WM Record 101

MEMORANDUM FOR:	Myron Fliegel, Section Leader Hydrology Section Geotechnical Branch Division of Waste Management, NMSS	DISTRIBUTION: WM 3101.1 s/f NMSS r/f WMGT r/f MGordon & r/f MKnapp JOBunting MJBell REBrowning	BWright DBrooks KWestbrook NColeman DGoode BCooke JPohle
FROM:	Matthew Gordon Hydrology Section Geotechnical Branch Division of Waste Management, NMSS		
SUBJECT:	ROCKWELL HANFORD OPERATIONS DOCUMENT SD-BWI-TI-254 "EFFECTIVE POROSITIES OF BASALT: A TECHNICAL BASIS FOR VALUES AND PROBABILITY DISTRIBUTIONS USED IN PRELIMINARY PERFORMANCE ASSESSMENTS"; LOO ET. AL., 1984

DOCUMENT REVIEW: "EFFECTIVE POROSITIES OF BASALT:
A TECHNICAL BASIS FOR VALUES AND PROBABILITY DISTRIBUTIONS
USED IN PRELIMINARY PERFORMANCE ASSESSMENTS", LOO ET.AL.,
SD-BWI-TI-154, ROCKWELL HANFORD OPERATIONS, 1984

FIGURE 2:
BASALT FLOW INTERIOR EFFECTIVE POROSITIES:
COMPARISON OF UNIFORM AND LOG-UNIFORM DISTRIBUTIONS

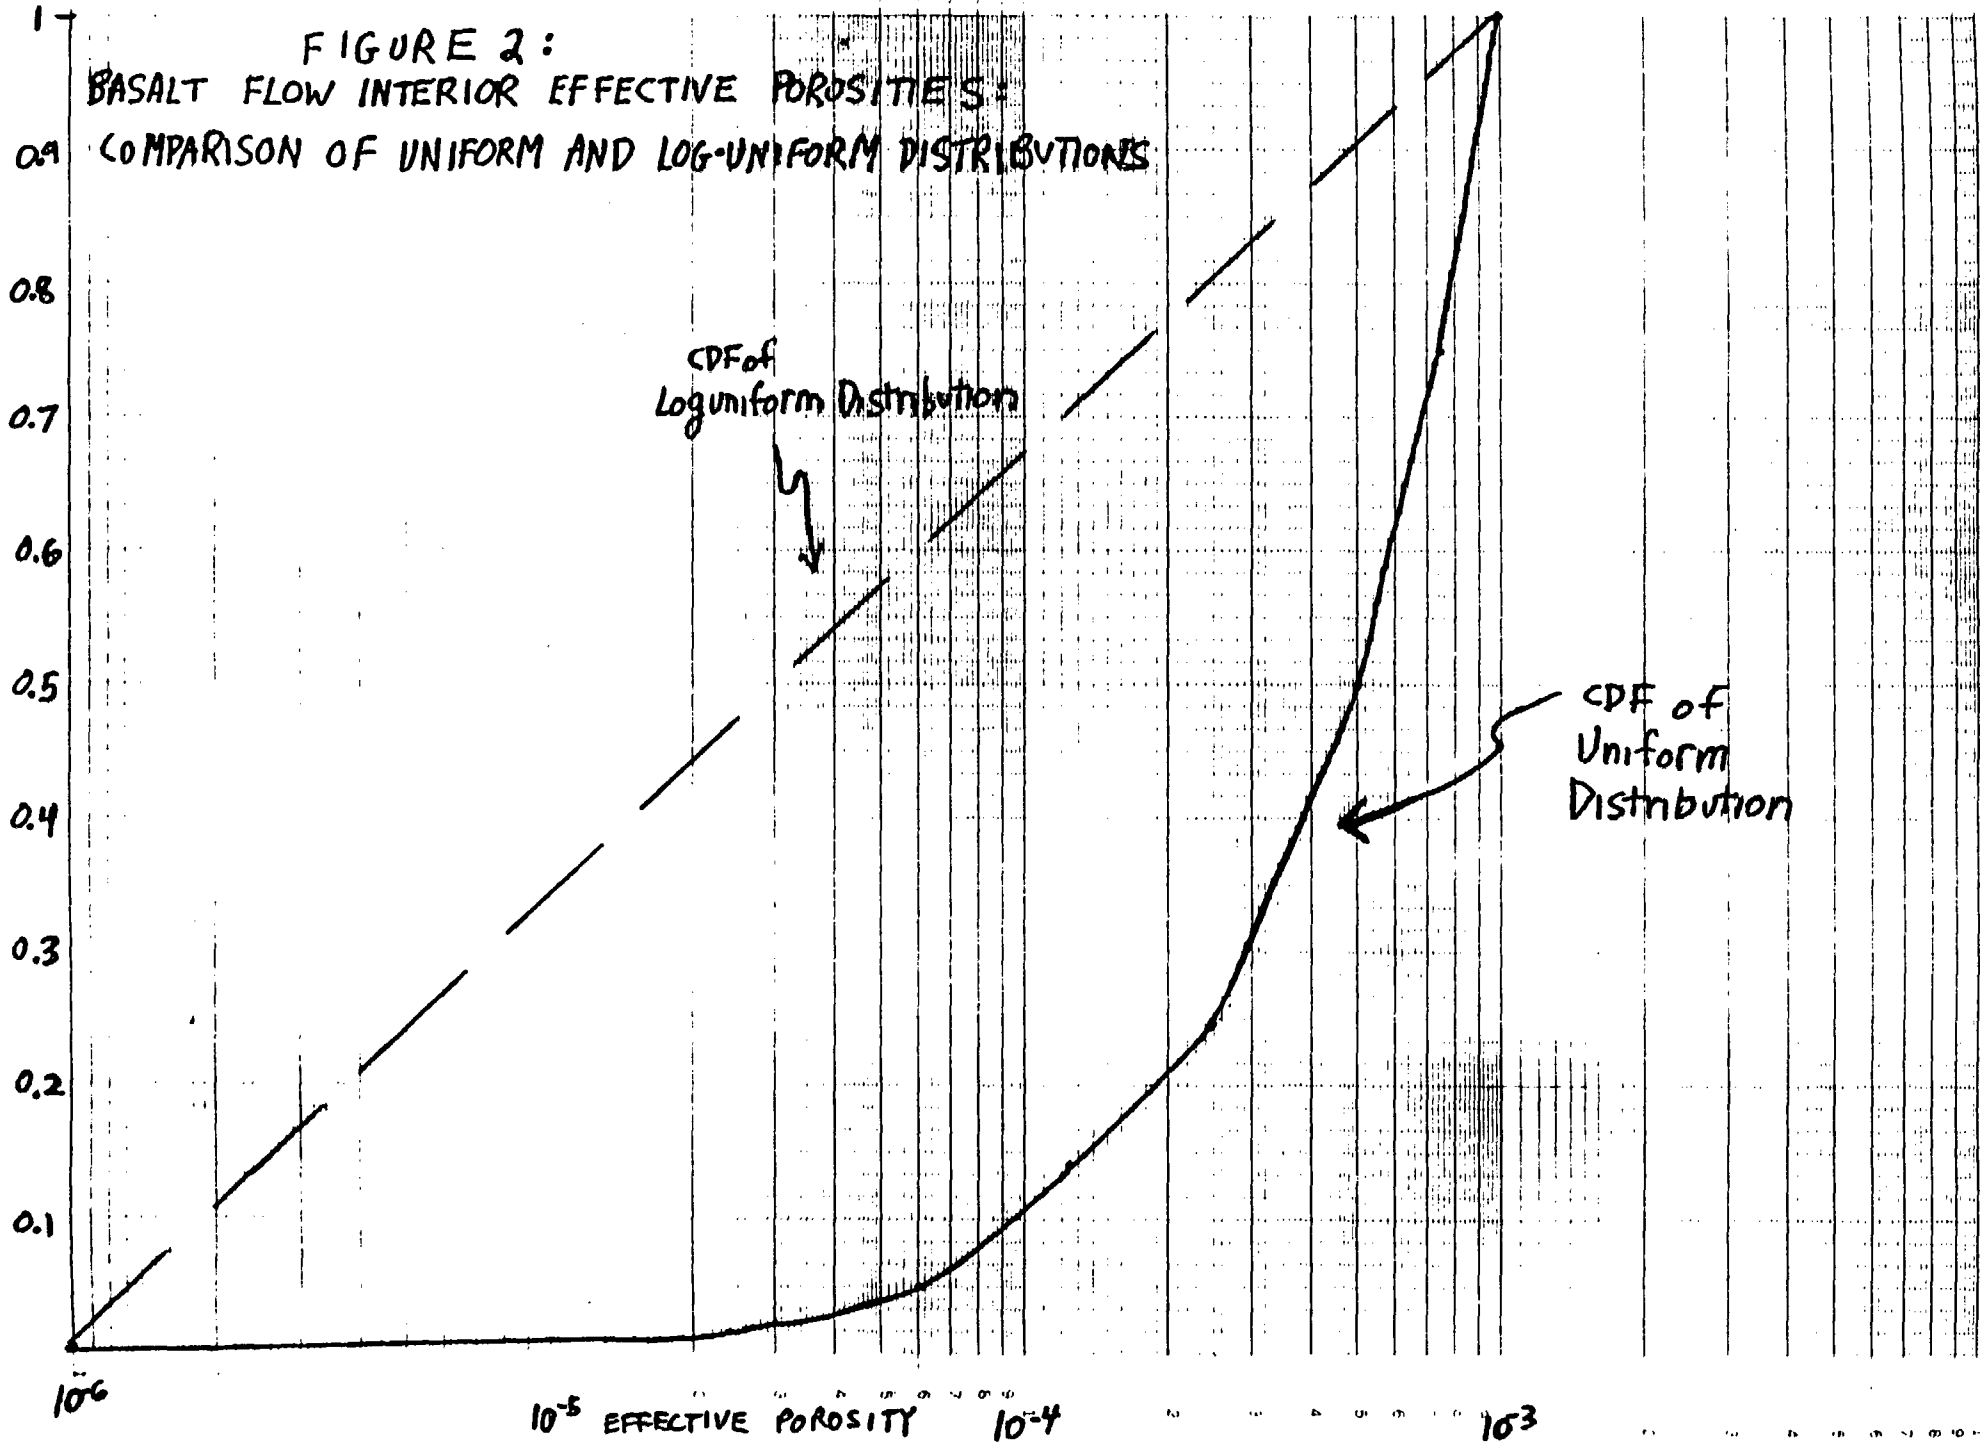
Alternatively, the assumption of a log-uniform distribution, which is suited for parameters with unknown distribution but which have ranges of uncertainty spanning several orders of magnitude, is considered reasonable and more appropriate than a uniform distribution. A uniform distribution assumption for the given effective porosity ranges implies a mean (and median) of 5×10^{-3} for flow tops and 5×10^{-4} for the flow interiors. A log-uniform distribution implies a median of 1×10^{-3} for flow tops and 3×10^{-5} for the flow interiors.

Figure 2 presents a comparison of the cumulative distribution function (CDF) of a log-uniform distribution with a uniform distribution for the Loo et.al. range

of basalt flow interior effective porosities. The abscissa indicates the probability that the effective porosity will be less than or equal to the value of effective porosity on the axis for the given distribution. The CDF of the log-uniform distribution is linear (sometimes called "triangular") on the log scale. It is evident from this figure that the uniform distribution assigns a very low probability to low values of effective porosity within the assigned range. In fact, the CDF of the uniform distribution would remain essentially unchanged regardless of the lower limit of the range. For example, if the lower limit of the range were decreased from 10^{-6} to 10^{-9} or even 10^{-13} , the median of the distribution would still be 5×10^{-4} . Thus, the choice of the upper limit is the controlling factor when the uniform distribution is assigned. I consider this appropriate only in cases where the upper limit is chosen reasonably and conservatively, which I do not consider to be the case for Loo et. al. for reasons described in the previous section.
